Work Order ID 151727

Item Name: Replacement Skidtube, High Gear with Standard Wearplates Fits LH or RH

DRAWING NO. D2650	TITLE 206/407 SKIDTUBE ASSEMBLIES	REV. F	DART AEROSPACE LTD ENGINEERING ORDER		D.E.O. NO. D2650-F-1	SHEET NO. SHEET 1 OF 1	SCALE NTS
DRAWN 12.10.12	CHECKED A.P.	MFG. APPR. 12.10.22	APPROVED 12.10.22		DE APPR. 12.10.22		
DATE	DATE	DATE	DATE	DATE	DATE

CHANGE C'BORED WELDED CROSSBOLT SPACERS TO SWAGED SPACERS

DETAIL G

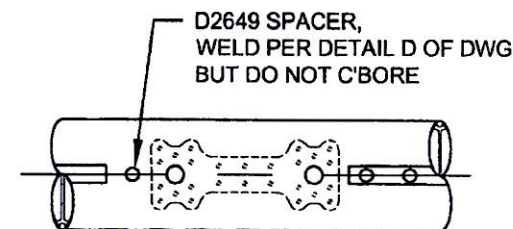
ADD DETAIL G BELOW, WHICH IS THE SAME SECTION VIEW AS DETAIL D OF DWG.

AMENDMENT TO DETAIL B
NOT TO SCALE

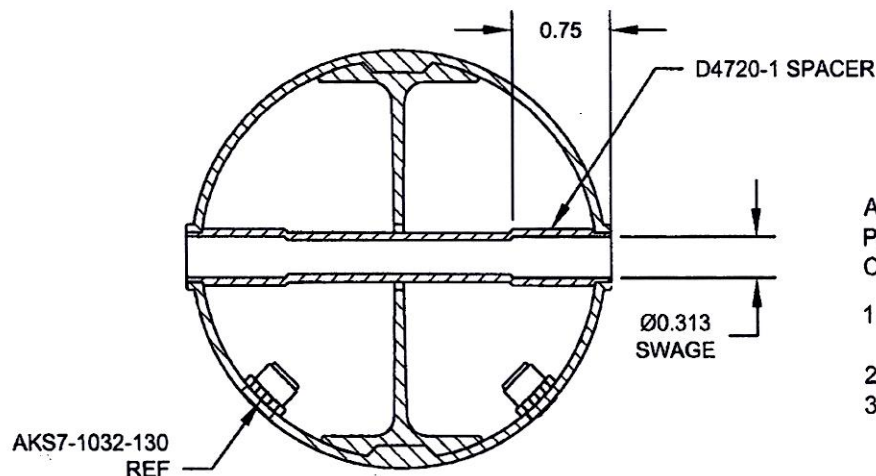
C'BORED HOLES ARE **NOW SWAGED** PER DETAIL G BELOW. FOR THE Ø0.375 HOLE THAT IS NOT C'BORED, WELD PER DETAIL D OF DWG (SEE AMENDED DETAIL B FOR REFERENCE).
